RE: Lot 8 Block 8 Unit 18 Volcano Cliffs Subd.

6511 Canavio Pl NW

RE: Lot 8 Block 8 Unit 18 Volcano Cliffs SAD 228 6511 Canavio Pl NW Grading and Drainage Plan **Engineers Stamp Date 5/30/16 (D10D003O8)**

GRADING & DRAINAGE PLAN 6511 CANAVIO PLACE, NW

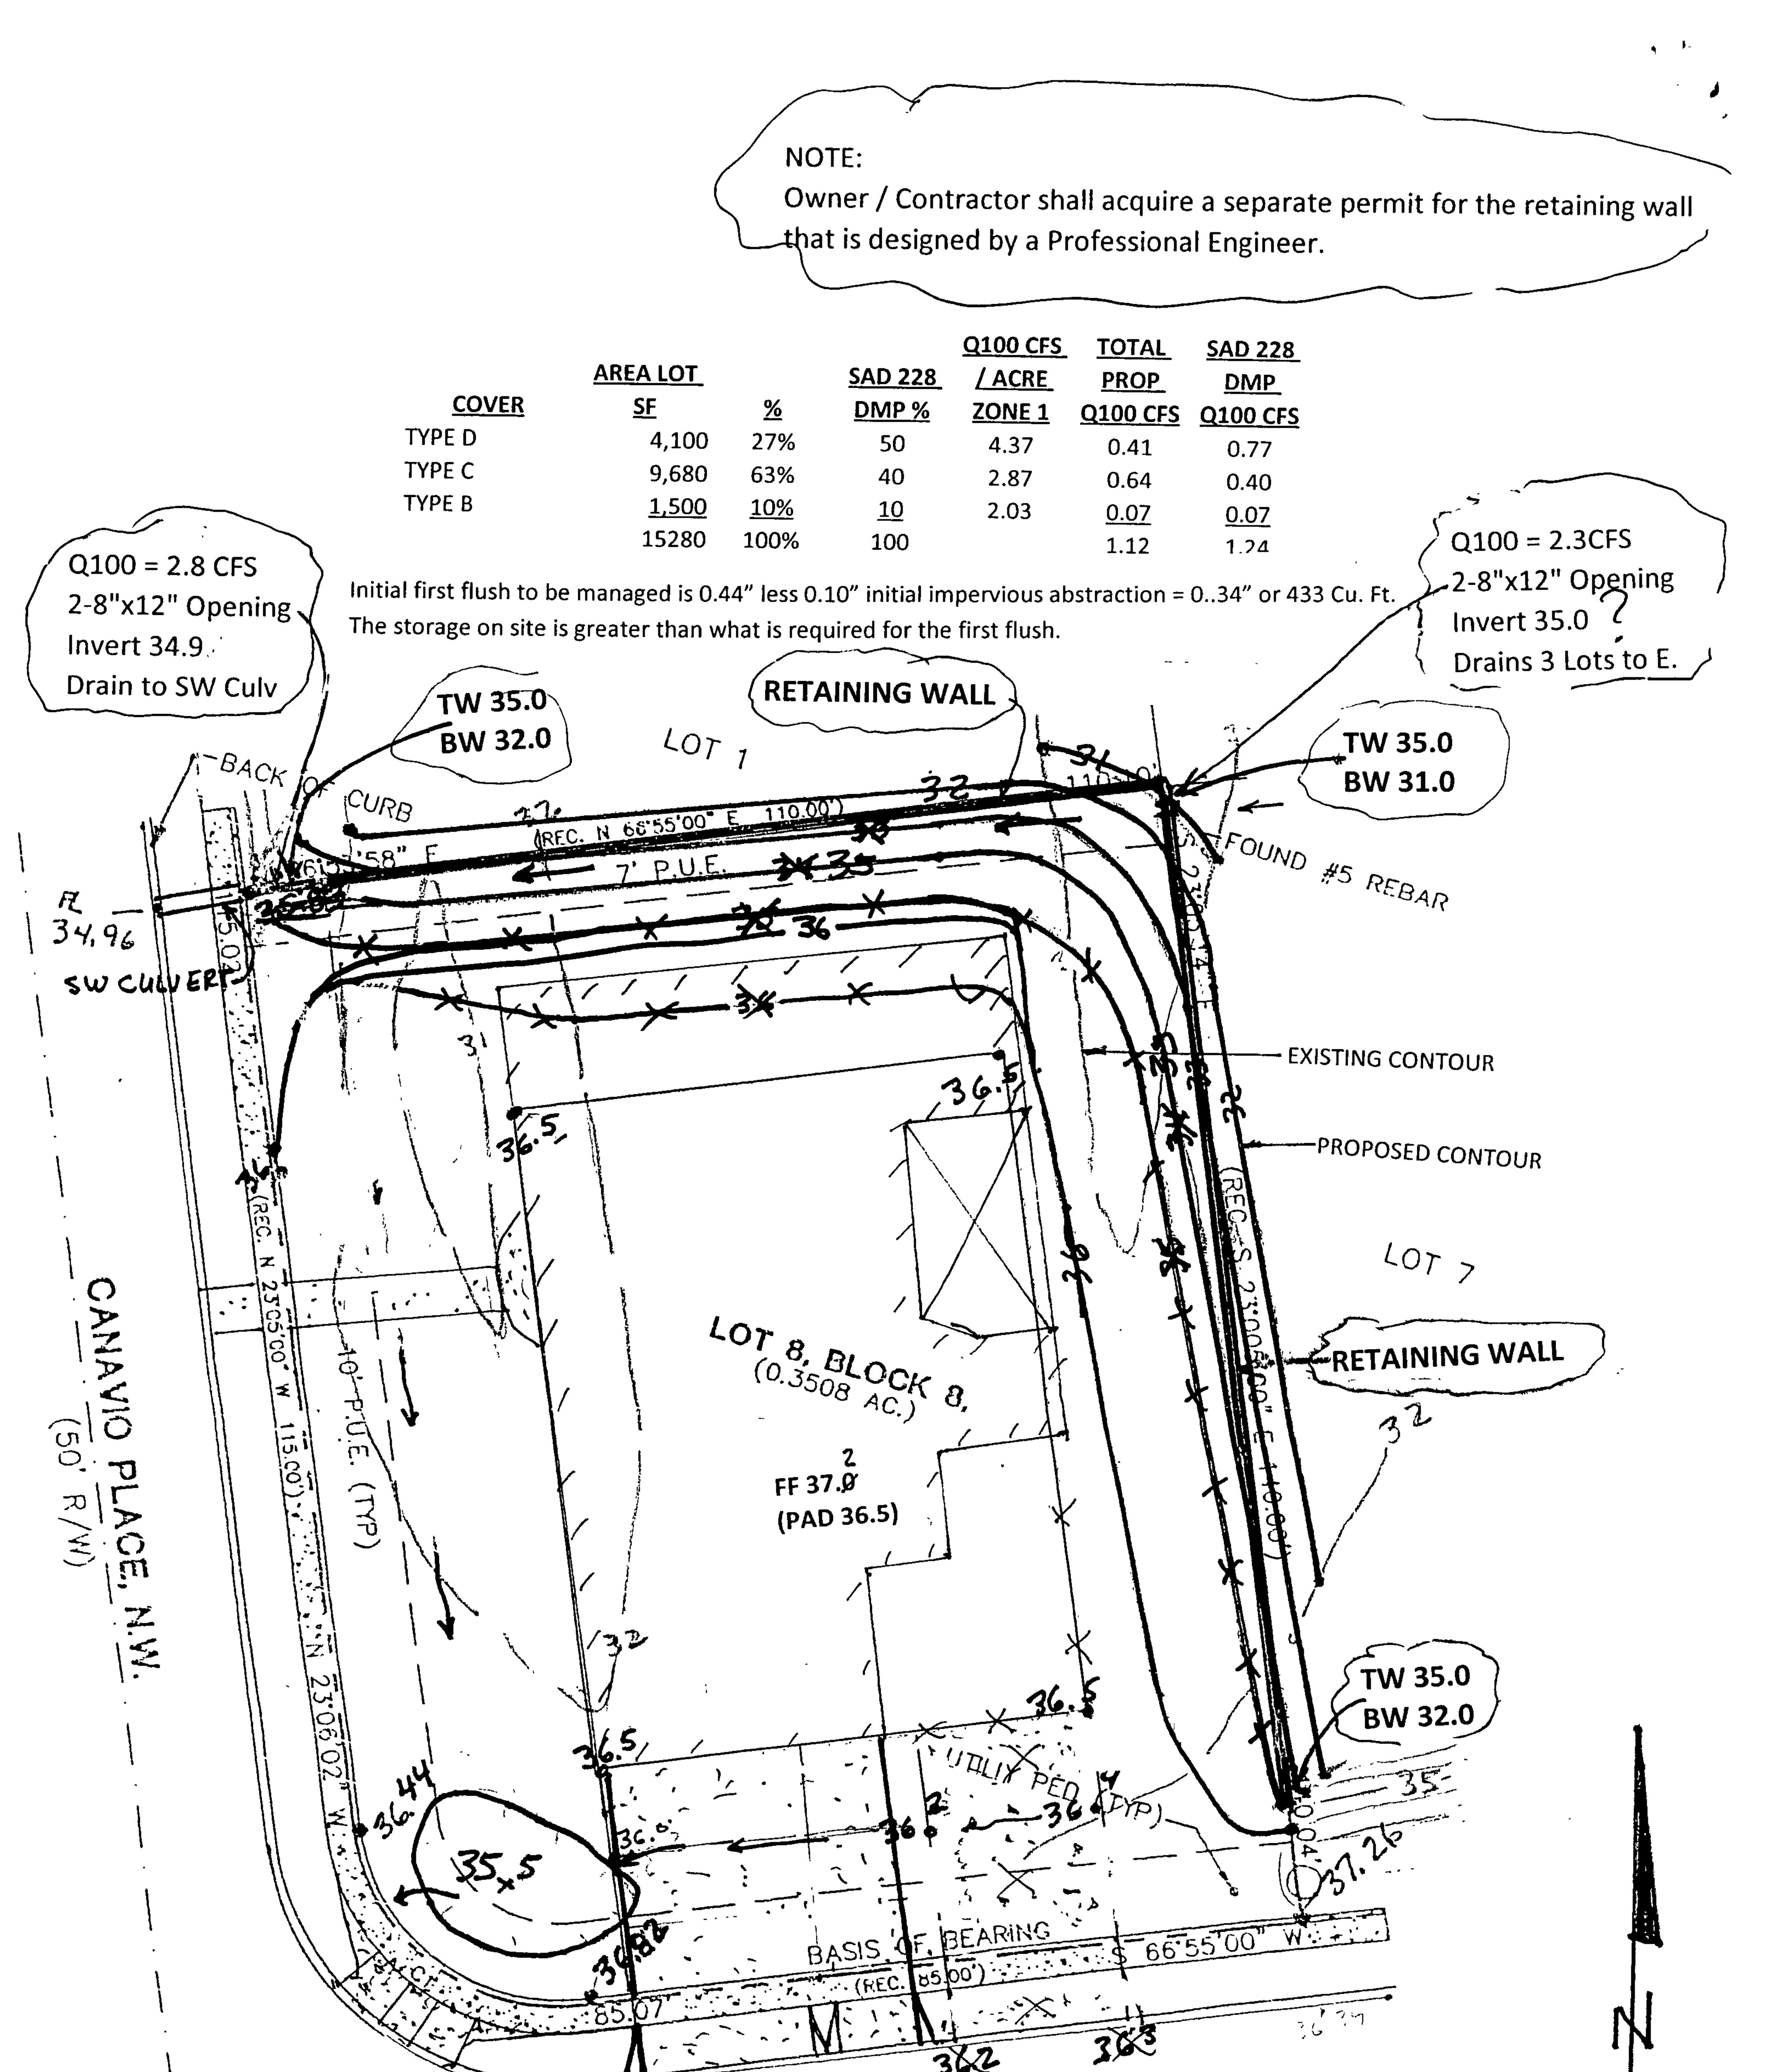
Provide flows for this property which exit out to Canavio Pl NW. - 1.12 cfs put Tbl.

The invert at the NE corner is incorrect; the properties to the east will not be able to release their flows as is required by the master drainage plan. - E. Lots will be raised.

Provide a swale from the Northeast corner to the Northwest corner, with a desiltation pond near the sidewalk culvert, unless the swale is made of gravel. The swale should be at least 1 foot away from the property line to avoid compromising the retaining. - Ole

The retaining walls need to be certified by this Engineering Firm or another. - /See

Thre is a plus to add wells - Connt As Built while of lave any questions, please contact me at 921 2006 - D

GRADING & DRAINAGE PLAN 6511 CANAVIO PLACE, NW

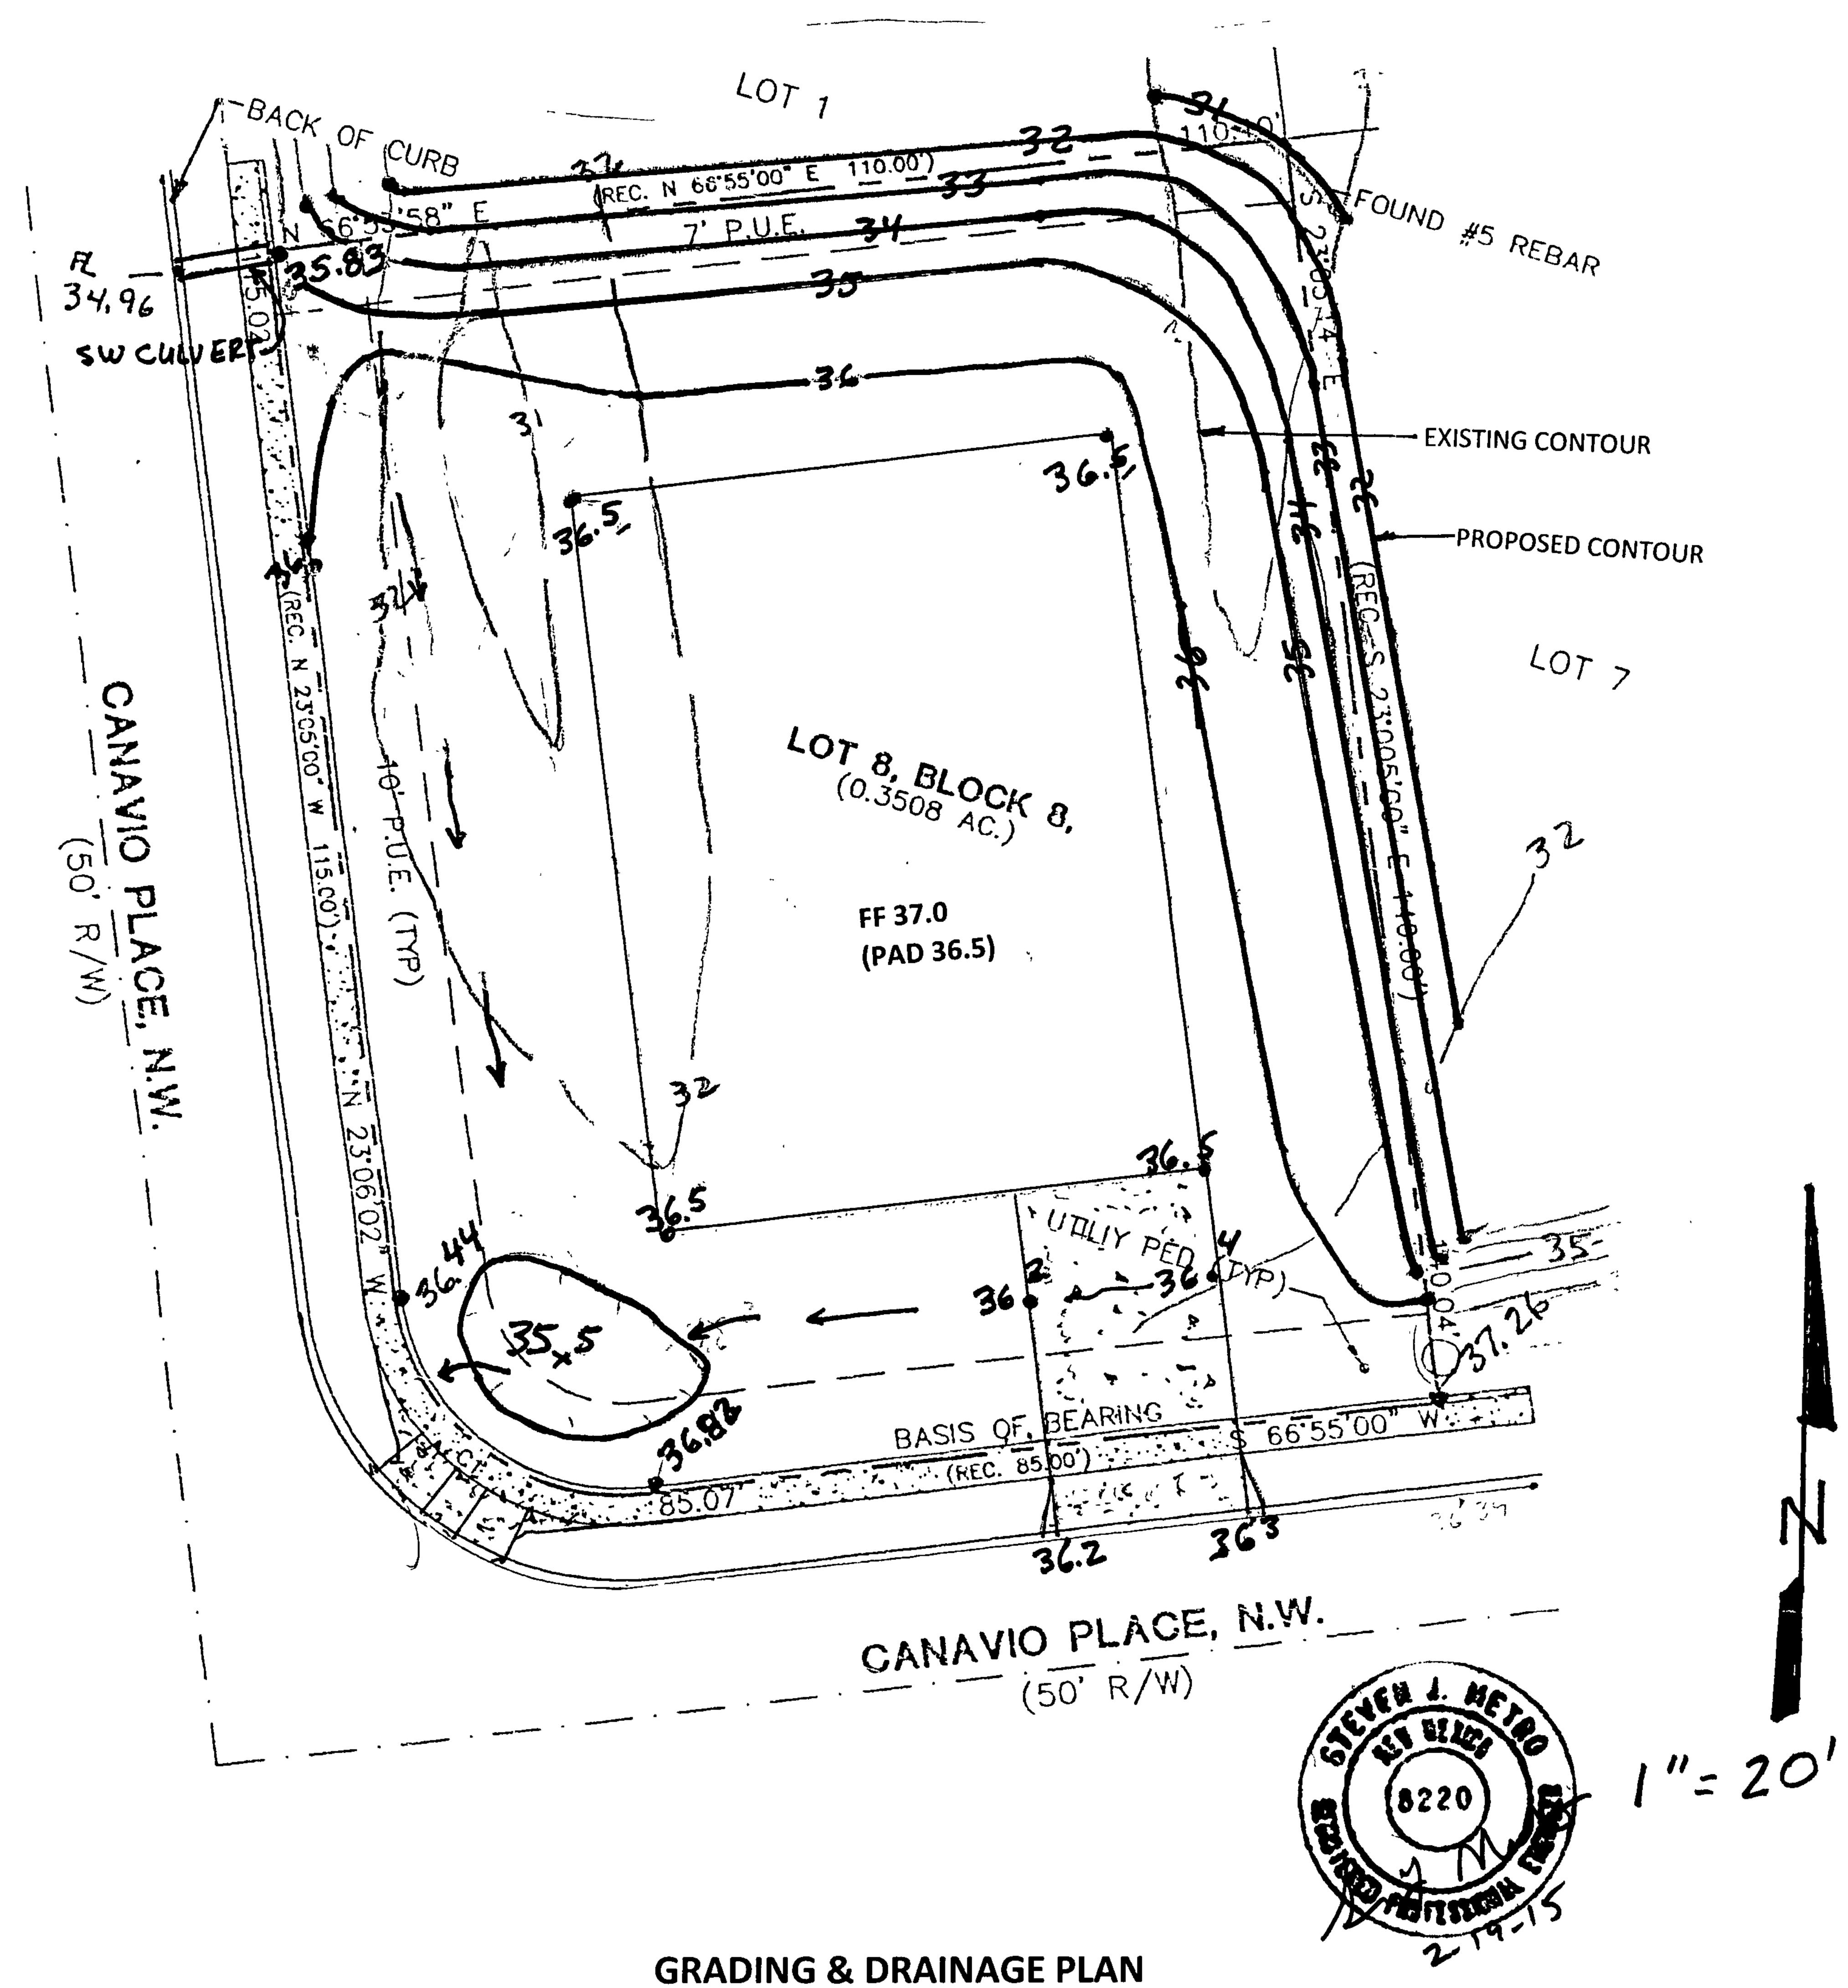
- Provide an opening in the east and west rear block walls. Provide the inverts and sizes of the openings.
- Provide how the lots to the east will drain.
- Inform the owner/contractor a separate wall permit is required. Also, the wall must be
 designed by a PE if retaining more than 18".
